Technical Service Bulletin

MODEL(S) AFFECTED: **T7 Rider Scrubber** - Models manufactured before serial number 10613731 (April 9, 2013).
Models manufactured in Europe before serial number T7xxx06952 (April, 2013).

SUBJECT: Potential drain hose damage due to careless machine operation when transporting with squeegee raised. If the right side of the squeegee assembly strikes a wall or obstruction with excessive force (see photos below), the left edge of the squeegee lift bracket will crush the drain hose causing damage and water leakage.

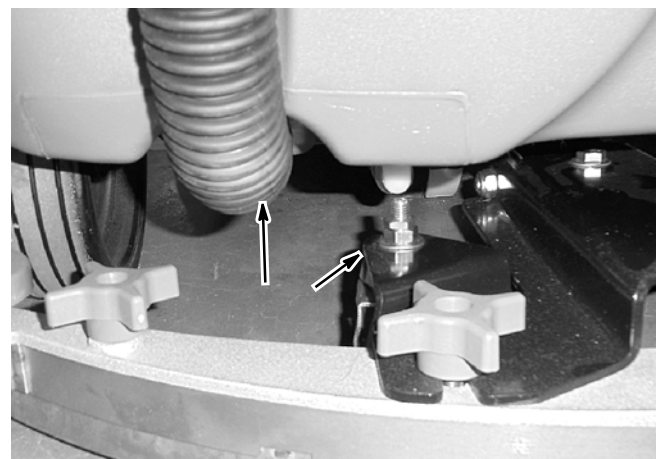
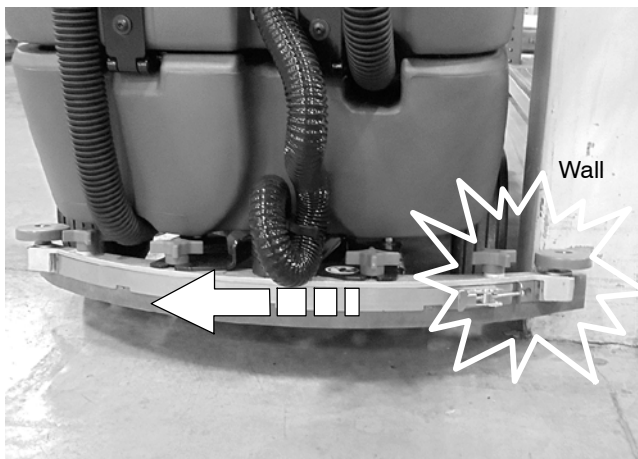
When squeegee assembly strikes a wall with excessive force, the left side of the squeegee lift bracket will crush drain hose.

1. Install upgraded squeegee lift bracket (p/n 1018725) which is slightly smaller in width that will provide ample clearance if squeegee assembly strikes a wall or obstruction with excessive force.
2. As an alternative to replacing the bracket, install a longer piece of protective edging (p/n 1020168) on the existing squeegee lift bracket as shown below.

To identify the upgraded bracket from an old bracket, the upgraded bracket measures 12.75 inches (32.4 cm) in width compared to the old bracket that measures 13.5 inches (34.3 cm).
